BOWRAL & DISTRICT HOSPITAL REDEVELOPMENT ENVIRONMENTAL ASSESSMENT REPORT SECTION 4.55(1A) MODIFICATION

3 OCTOBER 2019
P0014888
FINAL
PREPARED FOR NSW HEALTH INFRASTRUCTURE

Figure 3 – Level 2 (Approved and Modified Development)

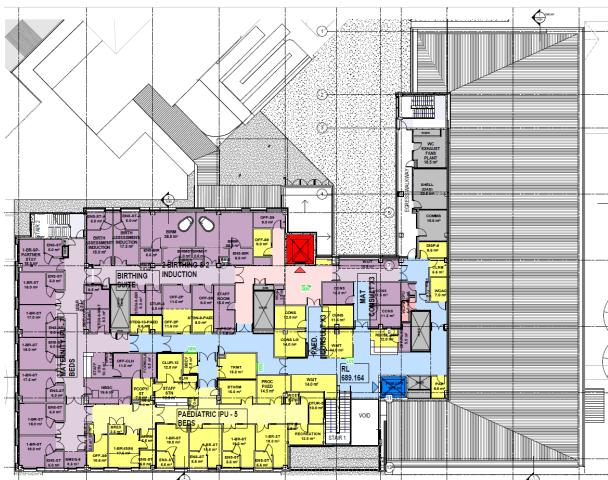
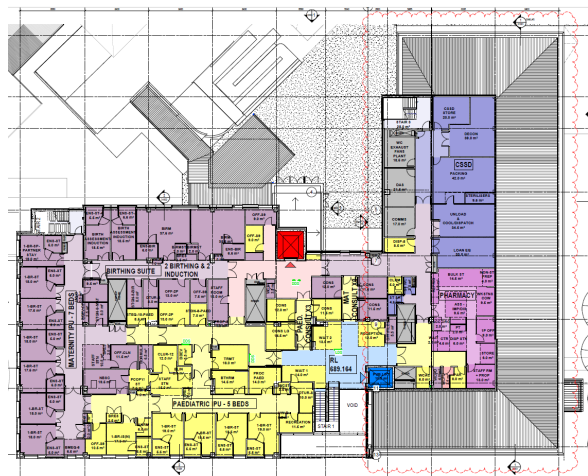
The additional 317.52 sqm floorspace to Level 2 accommodates hospital service rooms and back-of-house facilities (including the relocation of the existing Central Sterilising Department and pharmacy). The additional built form is set back from the main building line to reduce perceived bulk from the public domain, primarily Bowral Street to the north and residential buildings to the east.

The extracts below provide a comparison between the approved and modified development at Level 2.

Figure 4 – Level 3 (Approved and Modified Development)

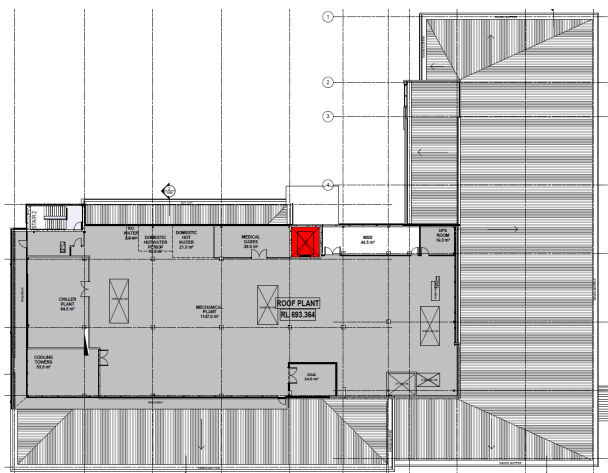
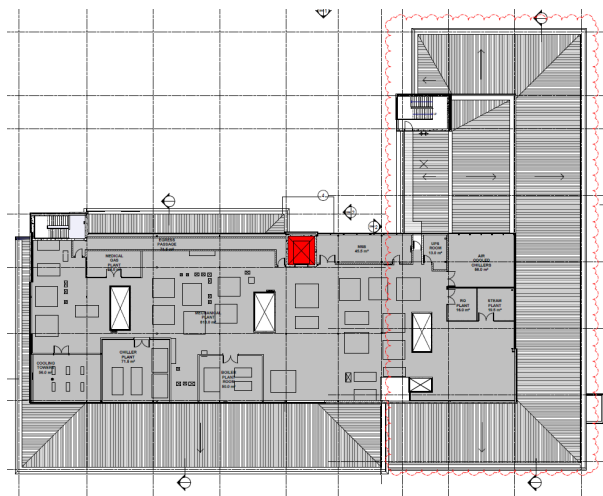
The additional 176.4 sqm floorspace to Level 3 will accommodate a new plant room and fire egress (providing fire egress from the plant room). Modifications to Level 3 include a suspended external walkway.

The extracts below provide a comparison between the approved and modified development at Level 3.

Figure 5 – Roof (Approved and Modified Development)

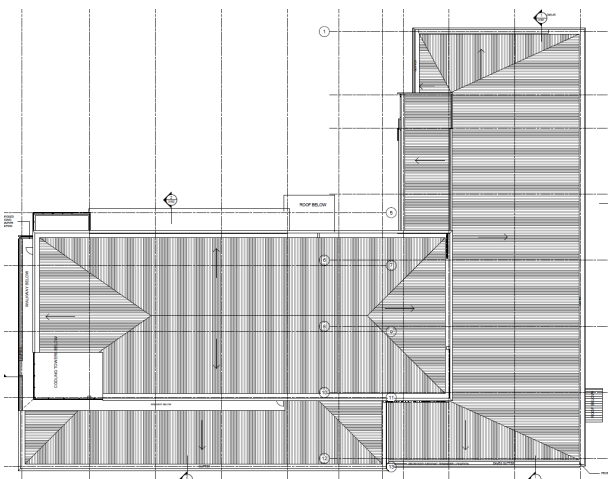
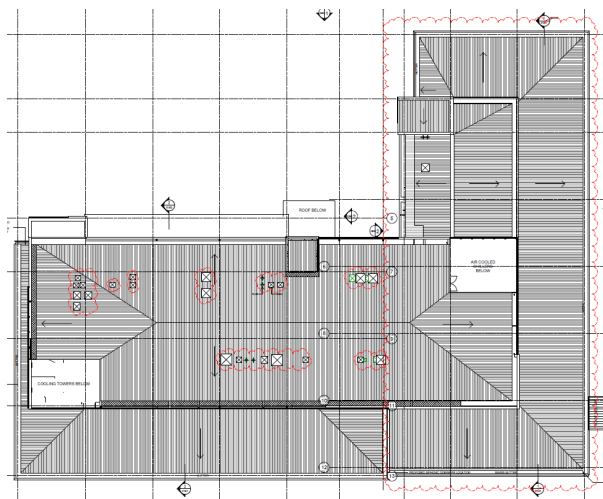
The modifications necessitate minor changes to the design of the rooftop level, being the inclusion of air cooled chillers on the north-facing façade. Roof flues and cowl are also provided at the roof top level.

The extracts below provide a comparison between the approved and modified development at roof level.
